**Planning Proposal to Rezone Land and Amend Minimum Lot Size on Lots at 407 & 457 Crookwell Rd Kingsdale (REZ/0001/2223)(PP\_2023\_414).**

I refer to your email of 20 March 2024 requesting pre-gateway comments on a Planning Proposal for land at 407 & 457 Crookwell Rd Kingsdale (Lots 70, 73 and 77 DP 1006688). The Proposal seeks to provide for low density and large lot residential development giving rise to predominantly sewered residential development, although a number of larger, residual unsewered lots are proposed in the north. Based on the supporting Water Cycle Management Study (WCMS), approximately 275 residential and rural-residential allotments could be created.

## **ATTACHMENT 1 - DETAIL**

**Map 1.** SLWCA Map for Residential Sewered Development.

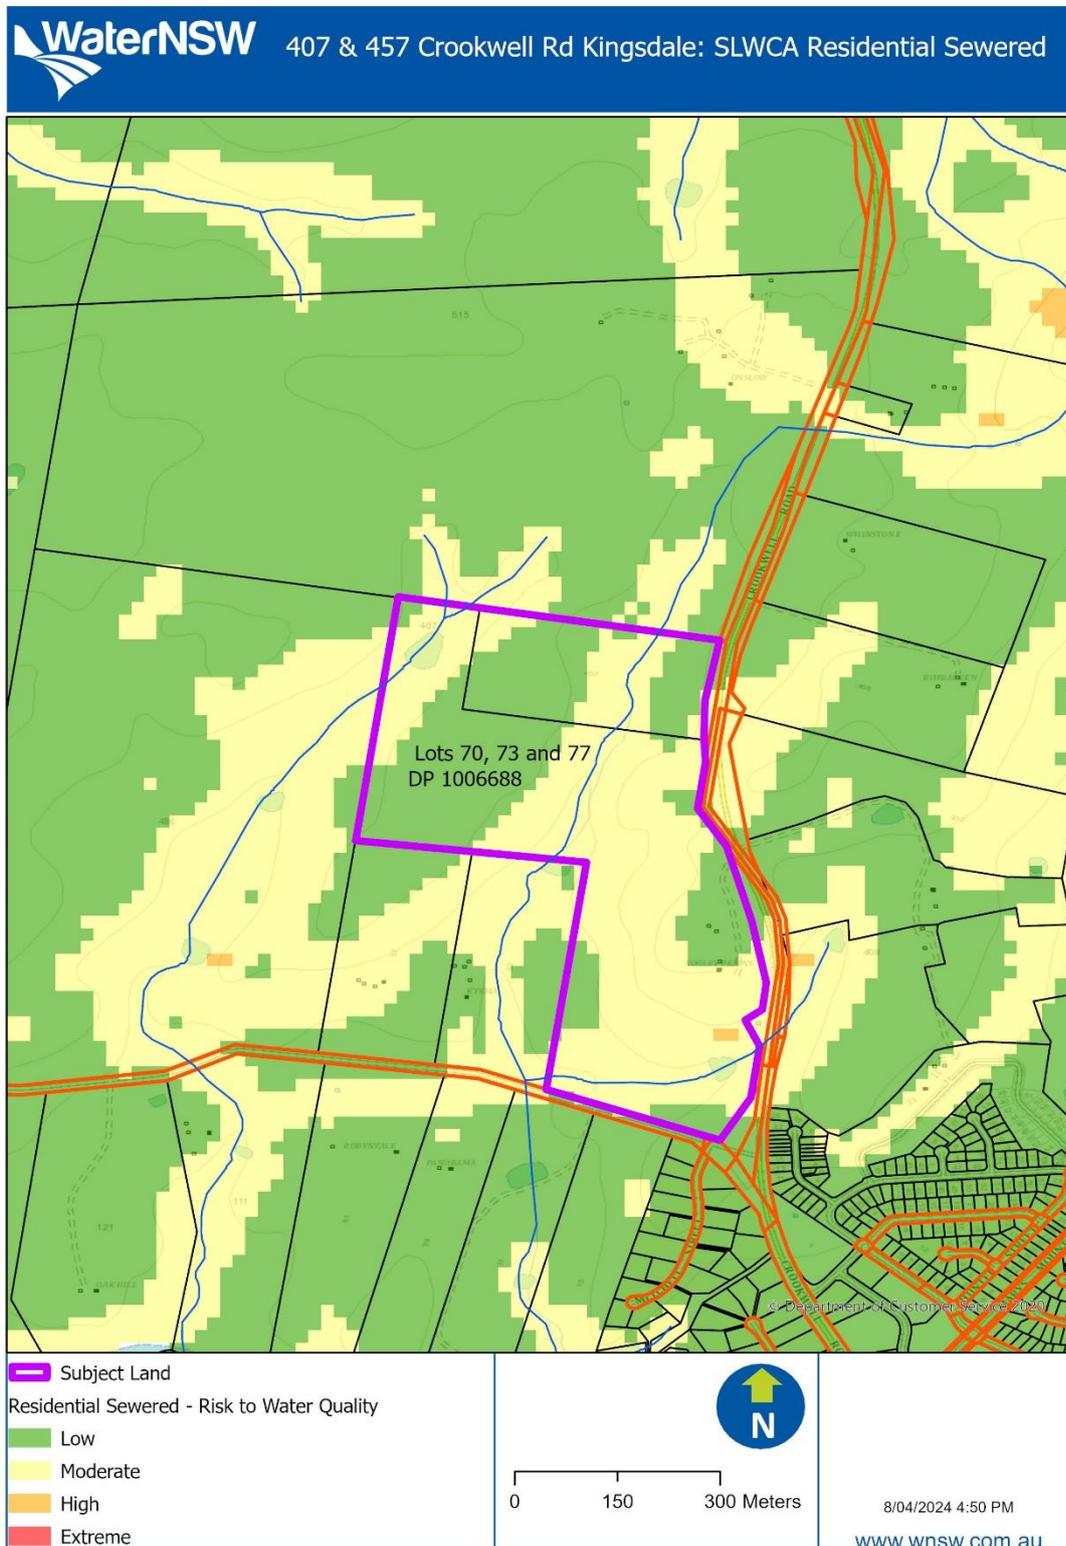
We include relevant Strategic Land and Water Capability Assessments (SLWCA) for the site in Attachment 2. The SLWCA for Residential Sewered Lots is relevant to those areas proposed to be sewered and zoned R2 (or R5 in the west). The SLWCA for Residential Unsewered Lots: 4000 m<sup>2</sup> to 2 ha is relevant for the R5 land in the north, which is to be unsewered and afforded a 2 ha MLS. Please note that the SLWCA modelling does not take into account flooding risk.

The SLWCA for Residential Sewered Lots indicates that the water quality risk varies from LOW to HIGH across the site. The area of HIGH risk is small. Most of the land has a MODERATE or LOW risk to water quality. Areas of HIGH risk have a LOW capability, areas of MODERATE risk have a MODERATE capability, while areas of LOW Risk have a HIGH capability for the relevant land use. Areas of HIGH and MODERATE risk are generally associated with the watercourses and lower lying areas on the site.

**Map 2.** SLWCA Map for Residential Unsewered Development: Lots 4000m<sup>2</sup> – 2 ha.

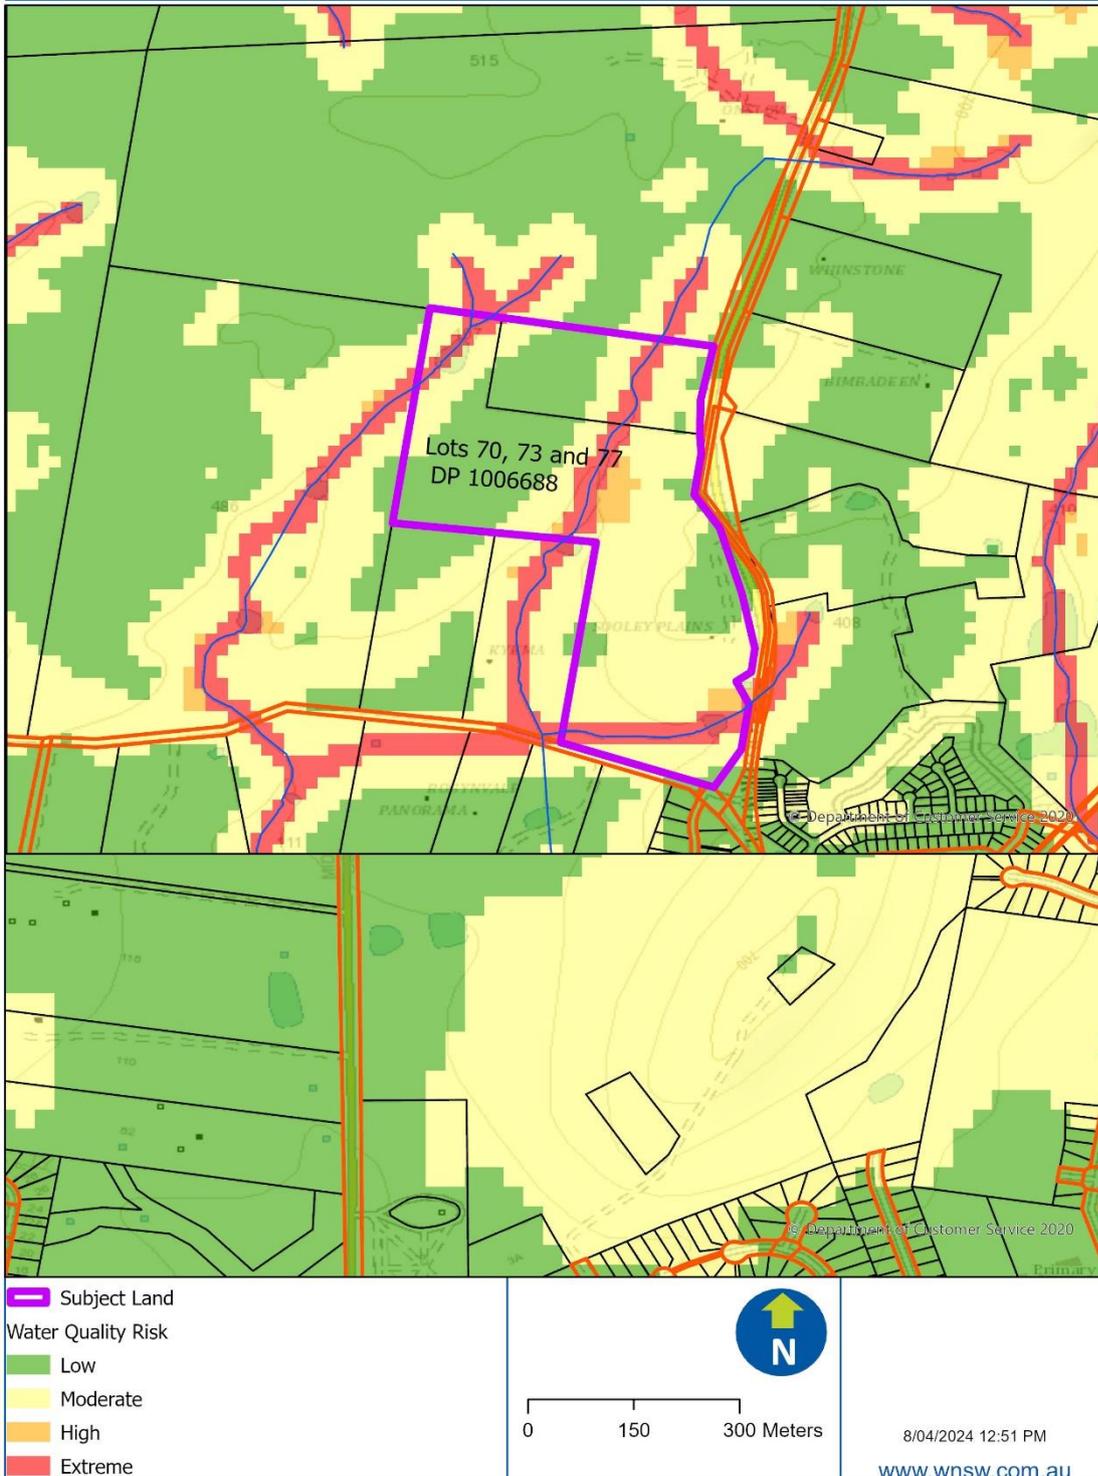
The SLWCA for Residential Unsewered Development indicates that the water quality risk varies from LOW to EXTREME across the site, including in the north where the unsewered lots are to be located. Areas of EXTREME risk are associated with the location of watercourses. Areas of EXTREME risk have a VERY LOW capability for unsewered development while areas of HIGH risk have a LOW capability. Areas of EXTREME and HIGH risk should be avoided. Areas of MODERATE risk have a MODERATE capability while areas of LOW Risk have a HIGH capability for unsewered development.
